Access Compliance Report

Public Rights-of-Way

Intersection ID: 29647	Main Street: BALLYSHANNON LN	Cross Street: SOUTHERN GARDEN LN	Location: NW
ADA ID: 62DBE517F9DA	Ramp Type: PerpDiag	Initial Pass/Fail: Fail	Overall Compliance: No
Severity Score: 8.75			
Codes/Mitigation Info/Possible Solution		Field Measurements/Component Compliance

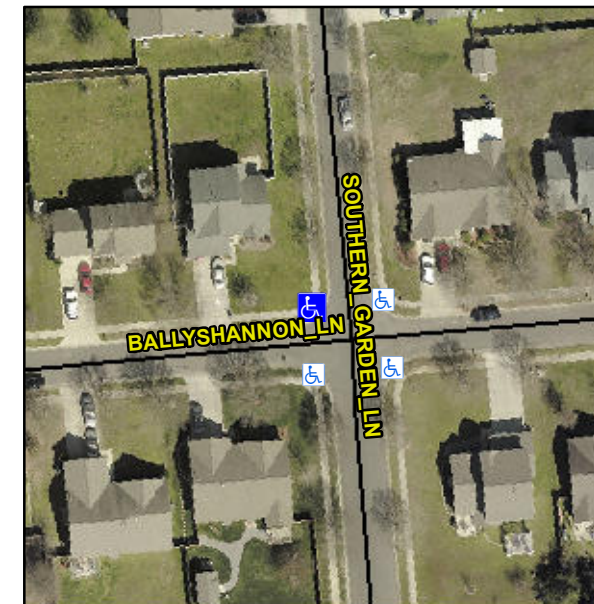
Not Found, R304.5.1

Compliance	Description	Data	Compliance	Description	Data
N/A	Ramp Length (in)	51.5	Yes	Ramp Slope (%)	6.3
No	Ramp Width (in)	36.3	Yes	Ramp XSlope (%)	2.0
N/A	Flare Type LT	N/A	N/A	Flare Type RT	N/A
N/A	Flare Slope LT (%)	N/A	N/A	Flare Slope RT (%)	N/A
N/A	Flare Traversable LT?	N/A	N/A	Flare Traversable RT?	N/A
N/A	Landing Length (in)	N/A	N/A	DWS Provided?	N/A
N/A	Landing Width (in)	N/A	N/A	DWS Contrast?	N/A
N/A	Landing Slope (%)	N/A	N/A	DWS Length (in)	N/A
N/A	Landing X Slope (%)	N/A	N/A	DWS Full Width?	N/A
N/A	Landing Curb? (Y/N)	N/A	N/A	DWS Offset (in)	N/A
N/A	Shared Landing?	N/A			
N/A	Gutter Ponding?	N/A	N/A	Gutter Slope (%)	N/A
N/A	Gutter Lip Ht (in)	N/A	N/A	Gutter X Slope (%)	N/A
N/A	Painted X Walk1?	No	N/A	Painted X Walk2?	No
	X Walk 1 Direction	To S		X Walk 2 Direction	To E
N/A	X Walk 1 Width (in)	N/A	N/A	X Walk 2 Width (in)	N/A
	X Walk 1 Slope (%)	1.4		X Walk 2 Slope (%)	0.6
	X Walk 1 X Slope (%)	0.5		X Walk 2 X Slope (%)	1.3

Remove & Replace Curb Ramp With Two New Directional Ramps or Equivalent.
